752 MARINE DRIVE

REVISED DESIGN CONCEPT

The following is a response to the comments provided by the Design Review Committee on November 20th, 2014. It addresses the following issues:

SOUTH FACADE

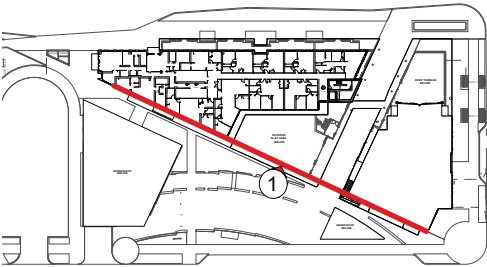
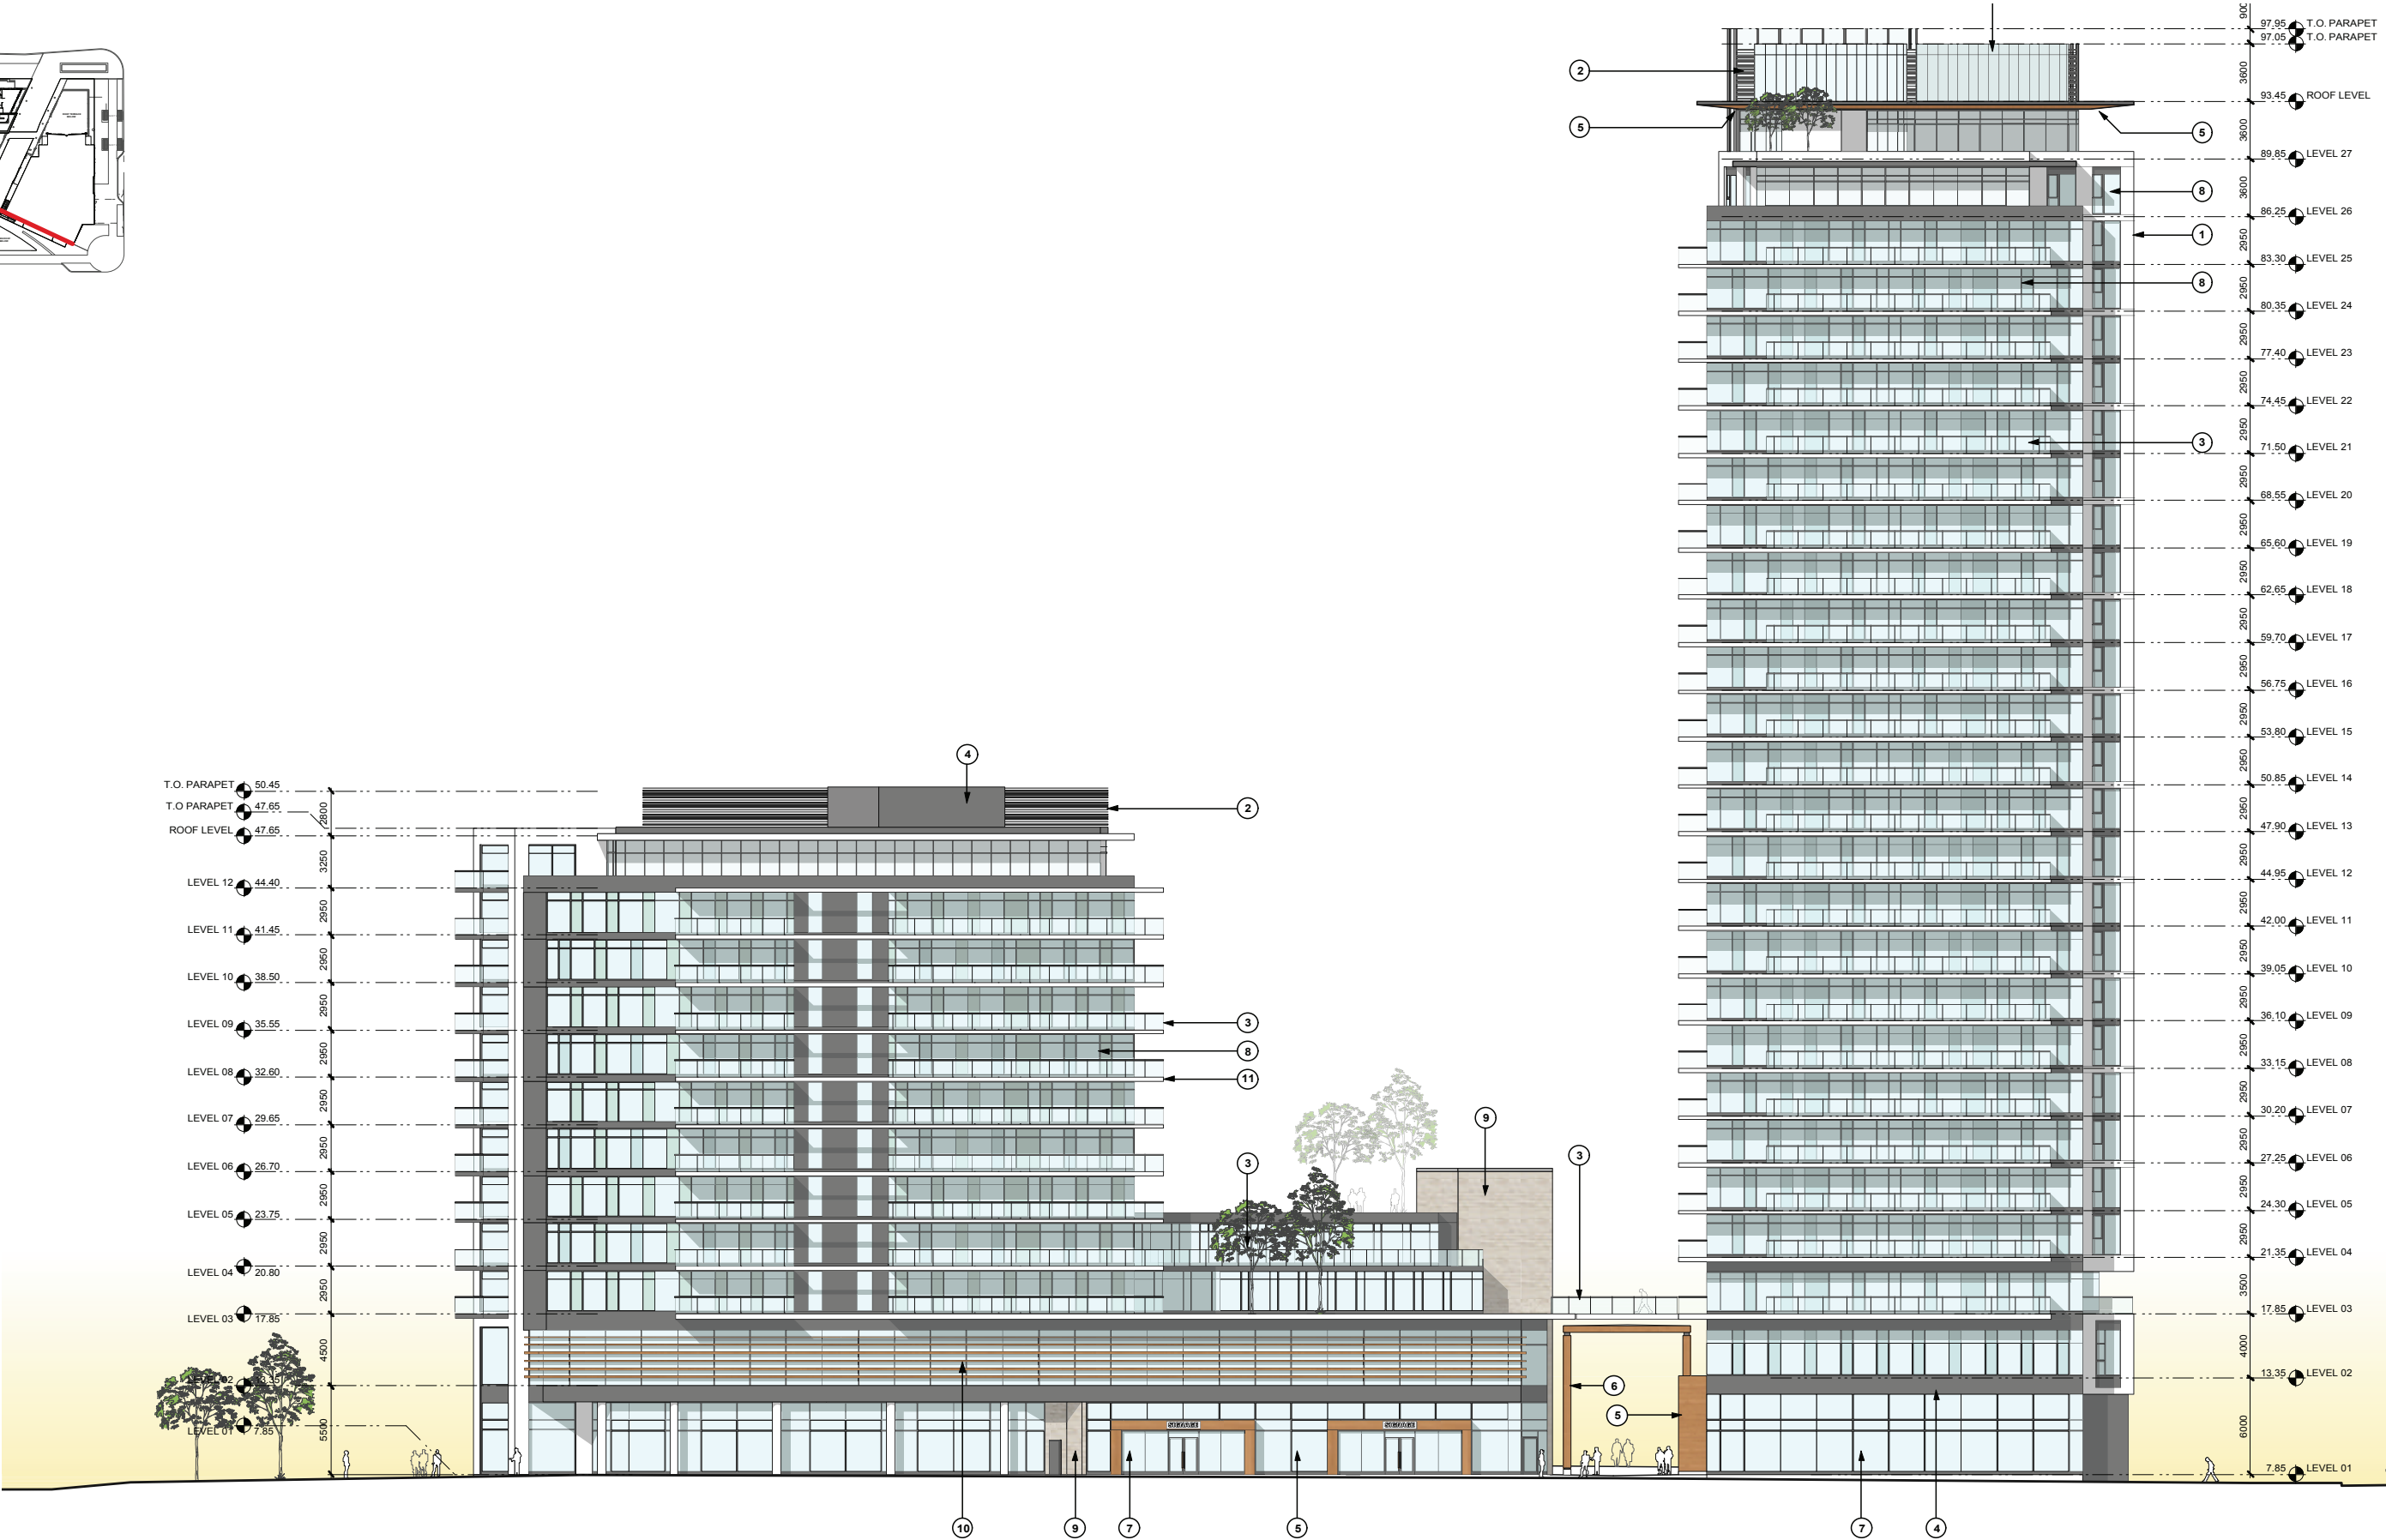
MORE OPACITY TO IMPROVE THERMAL PERFORMANCE AND CREATE MORE VISUAL INTEREST. THIS INCLUDES AN ALTERNATING RYTHYM OF SPANDREL AND VISION GLASS.
